**SUBJECT: COMANCHE PEAK NUCLEAR POWER PLANT, UNITS 3 AND 4
DOCKET NUMBERS 52-034 AND 52-035
RESPONSE TO HYDROLOGY SAFETY REVIEW OPEN ITEMS
(SECTIONS 2.4.12, 2.4.13, AND 2.5.4)**

Attachment 1 includes the six questions and their supplemental responses, and Attachment 2 provides the marked-up pages that incorporate the supplemental responses into the Final Safety Analysis Report (FSAR). For each mark-up, the associated supplemental response is annotated in the right margin. To assist the reviewer, the context of the marked-up pages is enhanced by including adjacent pages which may not have been changed.

Supplemental Responses to Requests for Additional Information

RAI 4314 (CP RAI #147) Question 02.04.12-8 S01
Question 02.04.12-9 S02

Figure 1-1 Revised Cross-Section Location Map

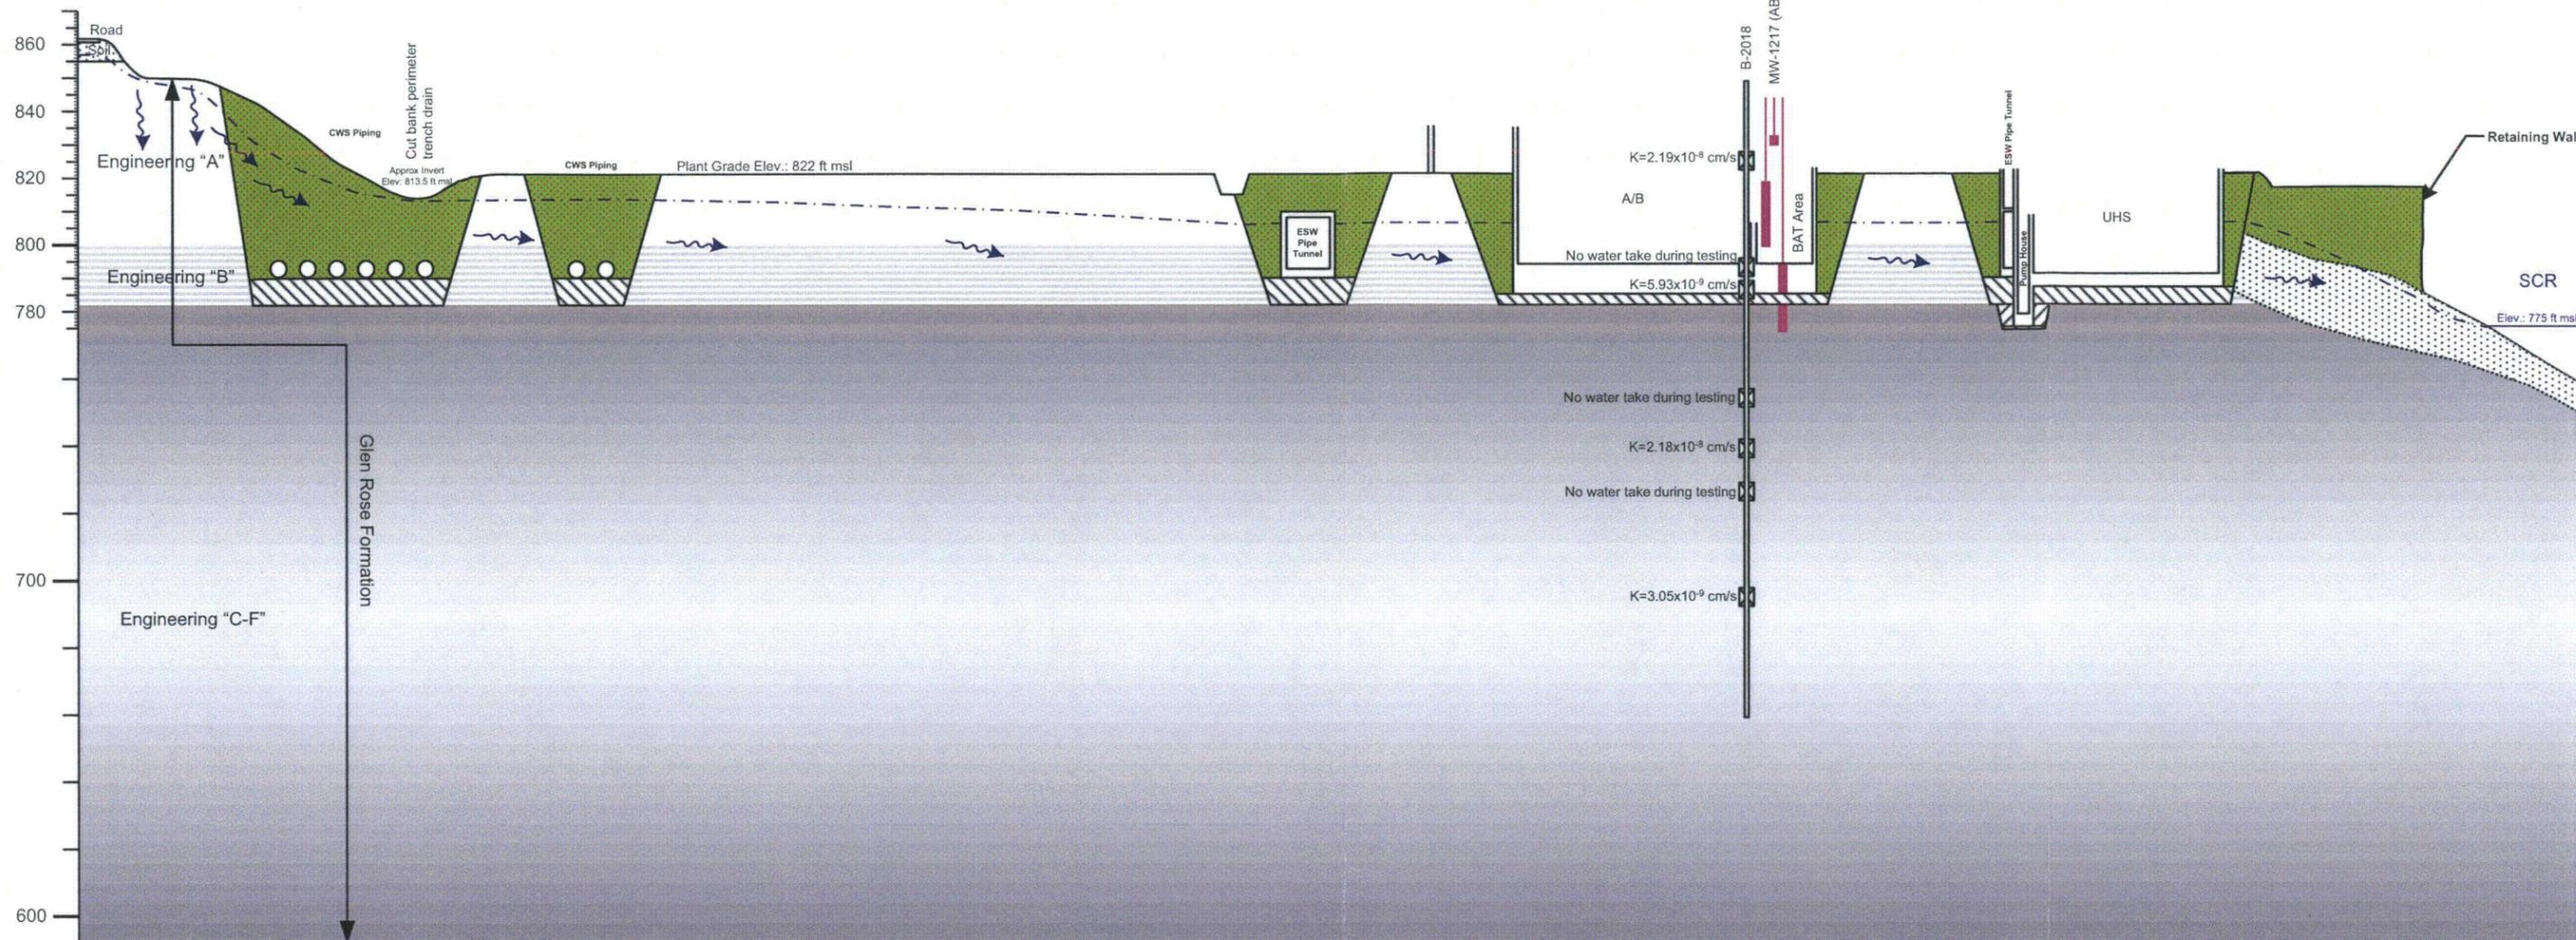
The extent of engineered fill placement is depicted on Figure 1-1. This figure shows the engineered fill within the Circulating Water System (CWS) piping trench¹ along the southern boundary of the plant site will underlie much of the southern cut bank. The CWS piping trench is shown between the western cut bank and the higher topographic areas to the west of the plant site. A significant portion of the CWS piping trench east of the Unit 3 turbine building is depicted as being in contact with the existing fill to the east of Unit 3 (see attached Figure 1-1). Due to its down-gradient position, the existing fill will provide a drainage location for the engineered fill.

Based on Figure 1-1, the easternmost contact wall between the CWS piping trench engineered fill and the eastern existing fill will be at least 350 ft wide (Figure 1-1) and 23.5 ft deep (maximum groundwater elevation at 813.5 ft msl minus elevation of the top of the piping trench fill concrete at 790 ft msl). Well MW-1214a (B2028), located near this contact location, reported the top of rock elevation at 781 ft msl. Therefore, this entire contact wall will be within the eastern engineered fill (Figure 1-6). This results in a contact surface area between the existing and engineered fill at that location of at least 8225 ft². This would be considered a minimum contact surface as excavation and stabilization requirements for installation of the CWS piping would most likely require additional excavation and placement of engineered fill or leveling concrete.

Figure 1-2 Revised Cross-Section 3a

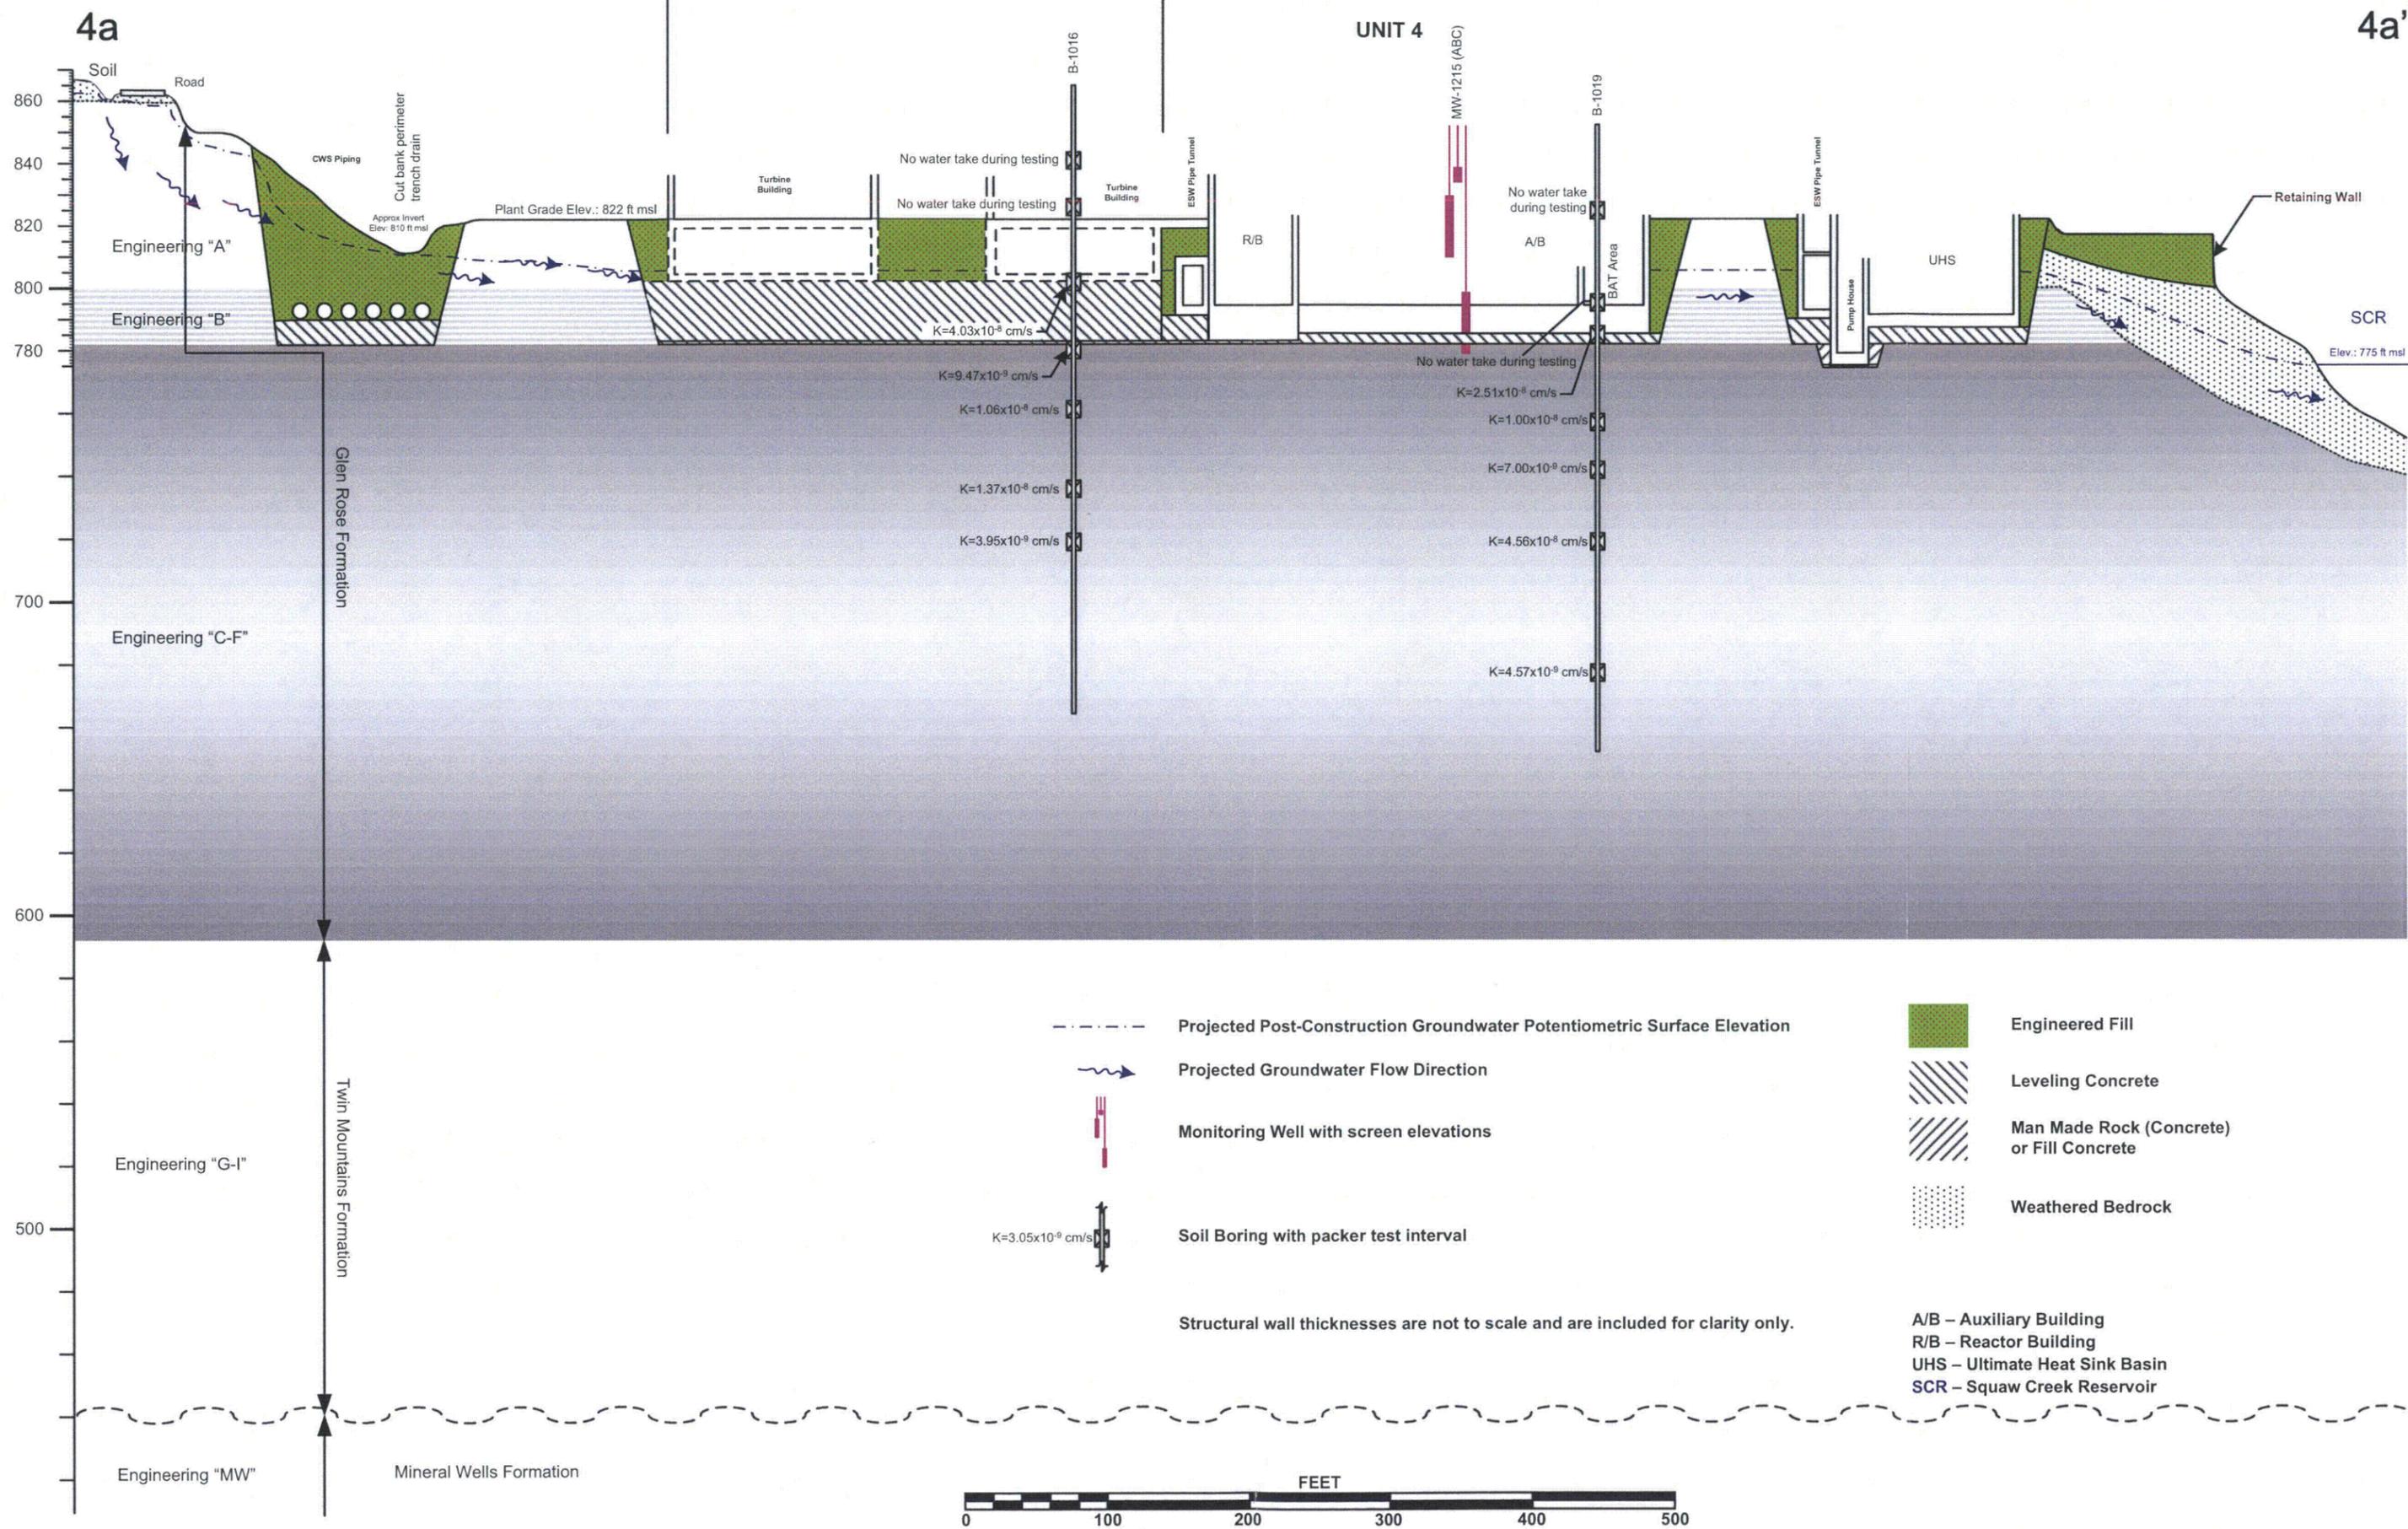
Cross sections through the plant site (Figures 1-2 and 1-4) show the CWS piping trenches are embedded to the approximate depth of other sub grade structures and intersect any horizontal bedding planes present above the engineering "C" layer.

Horizontal seepage of groundwater along bedding planes from the south or west will intersect the CWS piping trenches prior to reaching the engineered fill surrounding the Auxiliary Building or Reactor Building and will be transported within the engineered fill to the existing fill. The engineered fill properties have not been designed, so the nature of the engineered/existing fill contact is unknown at this time.

Figure 2.4.12-212 Groundwater Flow Path

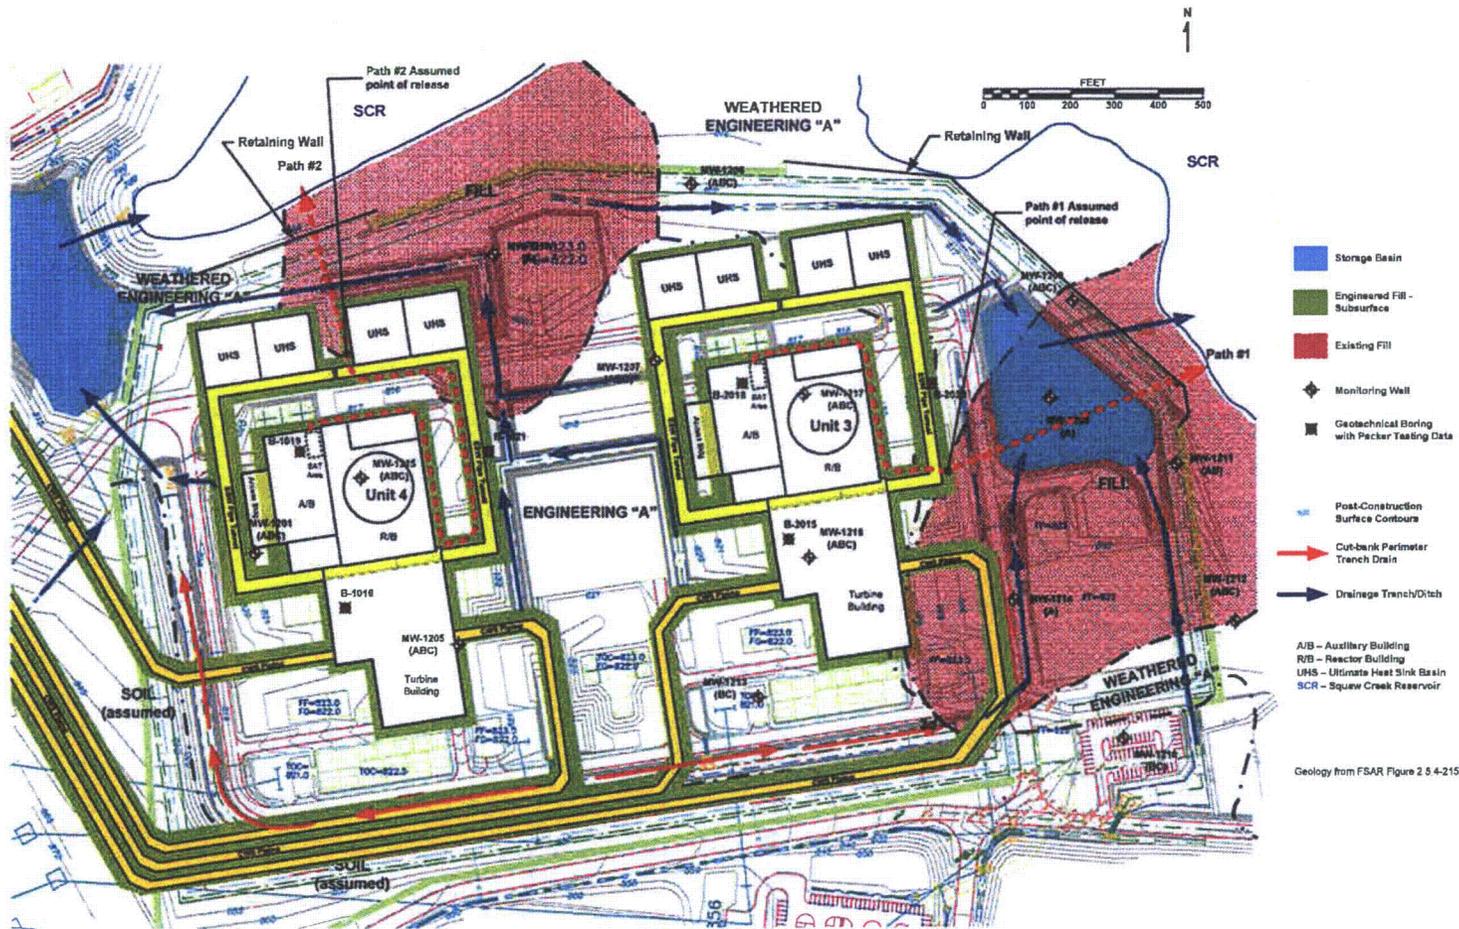
The extent of engineered fill placement is depicted on FSAR Figure 2.4.12-212. This figure shows the engineered fill within the CWS piping trench along the southern boundary of the plant site will underlie much of the southern cut bank. The CWS piping trench is shown between the western cut bank and the higher topographic areas to the west of the plant site. A significant portion of the CWS piping trench east of the Unit 3 turbine building is depicted as being in contact with the existing fill to the east of Unit 3. Due to their down gradient position and high permeability, the existing fills east of Unit 3 and north of Unit 4 will provide a drainage location for the engineered fill.

The easternmost contact surface between the CWS piping trench engineered fill and the existing fill located east of Unit 3 will be at least 350 ft wide (Figure 2.4.12-212) and 23.5 ft deep (assuming the maximum groundwater elevation at 813.5 ft msl minus elevation of the top of the piping trench fill concrete at 790 ft msl). Monitoring well MW-1214a (B2028) located near this contact location reported the top of rock elevation at 781 ft msl; therefore, this entire contact surface will be within the eastern engineered fill. This results in a contact surface area between the existing and engineered fill at that location of at least 8225 ft². This would be considered a minimum contact surface as excavation and stabilization requirements for installation of the CWS piping would most likely require additional excavation and placement of engineered fill or leveling concrete.

Figure 2.4.12-213 Post Construction Release Flow Path #1

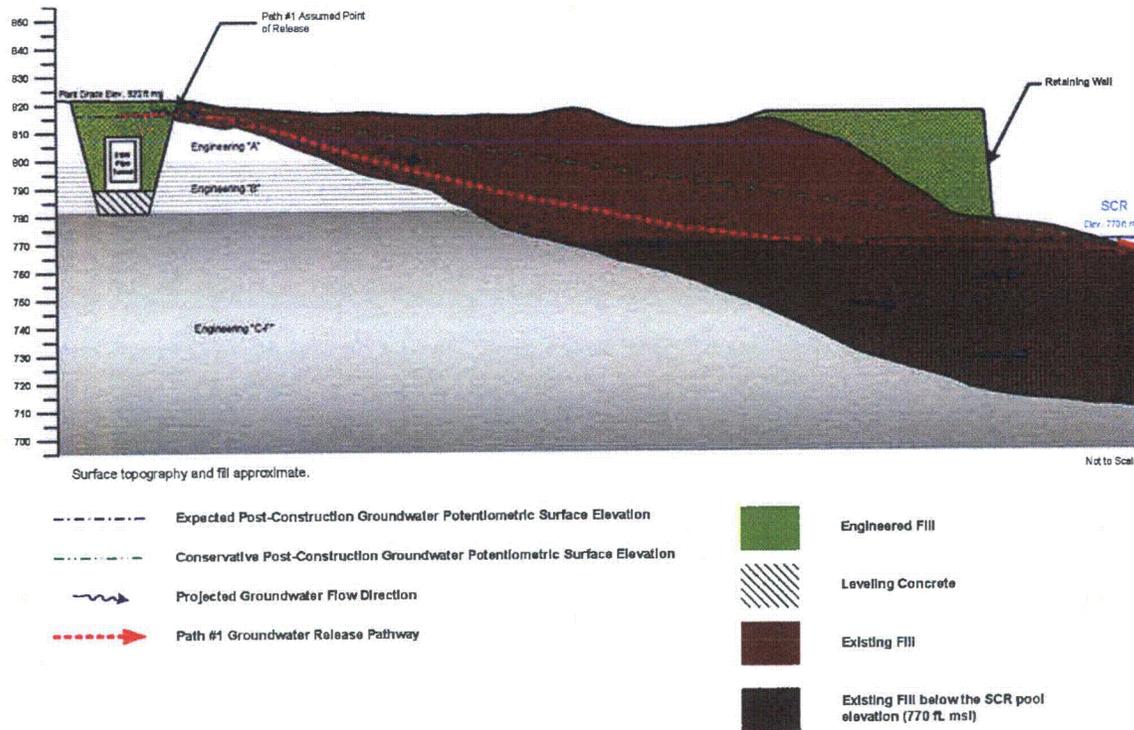
For groundwater Path #1 (Figure 2.4.12-213), it is assumed that a release from the Unit 3 BAT would instantaneously travel out of the Unit 3 A/B into the engineered fill surrounding the A/B and R/B. For conservatism, it is assumed that this release would travel as a slug without any dilution within the groundwater present in the engineered fill. It would then travel through the engineered fill of the Unit 3 R/B and A/B and the ESW piping trench to the closest engineered/existing fill interface, located to the east of the Unit 3 turbine building (Figure 2.4.12-212). Since the hydraulic properties for the engineered fill have not yet been determined, it is assumed that the transport time to the fill interface will be negligible and no retardation or dilution of the released Unit 3 BAT contents is credited. At the assumed point of release, the released Unit 3 BAT contents will enter the existing fill east of Unit 3. The geometry and properties of the existing fill/engineered fill contact are presently unknown, therefore, for conservatism, it is assumed the contact will not retard any groundwater or radionuclide flow from the engineered fill into the existing fill. The released Unit 3 BAT contents will then travel 600 ft through the existing fill to the closest shoreline location on SCR. The travel time from the release point to SCR via the existing fill east of Unit 3 is conservatively estimated at 145 days.

The engineered fill surrounding the ESW tunnel is in contact with the existing fill on the east side of the ESW tunnel as depicted on Figure 2.4.12-213. As depicted on Figures 2.4.12-213 and 2.4.13-201, a stormwater retention pond is located east of Unit 3 that has an overflow elevation of approximately 810 ft msl, and a bottom elevation of approximately 800 ft msl. Groundwater elevations within the existing fill will be approximately equal to the surface elevation of SCR. For the purpose of the existing fill groundwater calculation, an SCR minimum operating elevation of 770 ft msl was used. The bottom of the stormwater retention pond is

Figure 2.4.12-214 Post Construction Release Flow Path #2

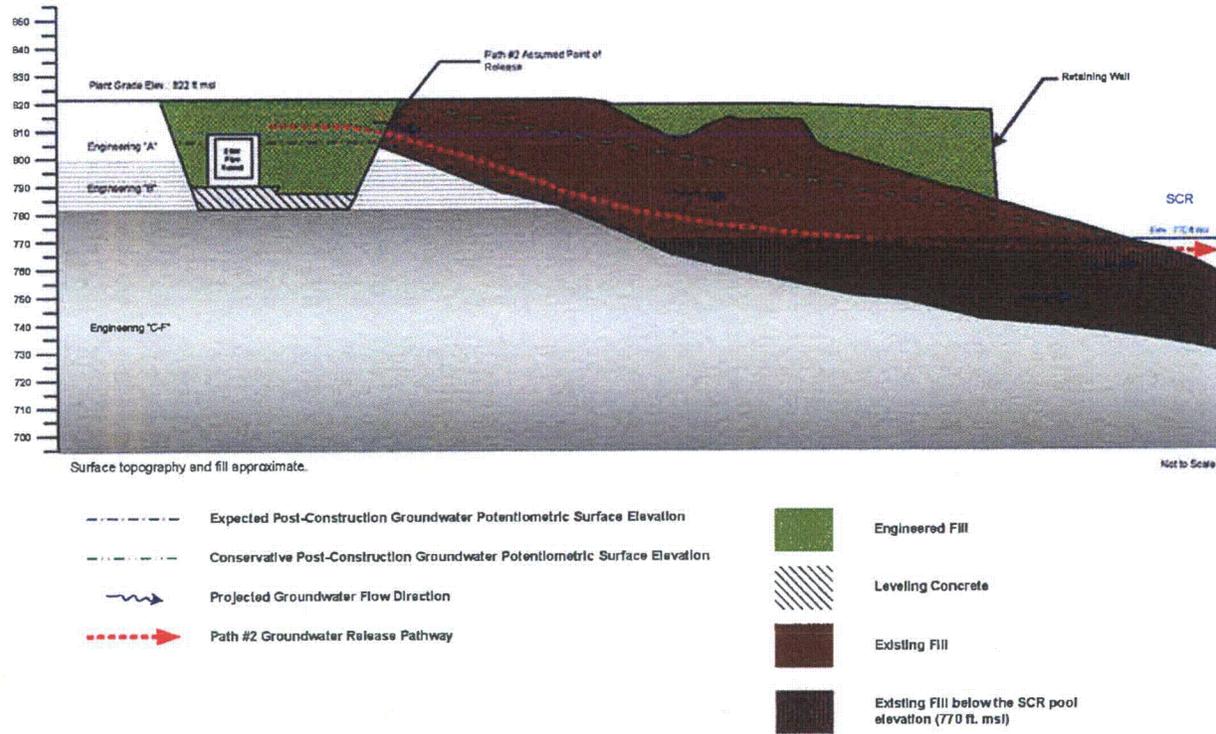
Cross sections depicting the post construction groundwater flow pathways from CPNPP Unit 4 to SCR are presented in Figure 2.4.12-214.

For groundwater Path #2 (Figure 2.4.12-214), it is assumed that a release from the Unit 4 BAT would instantaneously travel out of the Unit 4 A/B into the
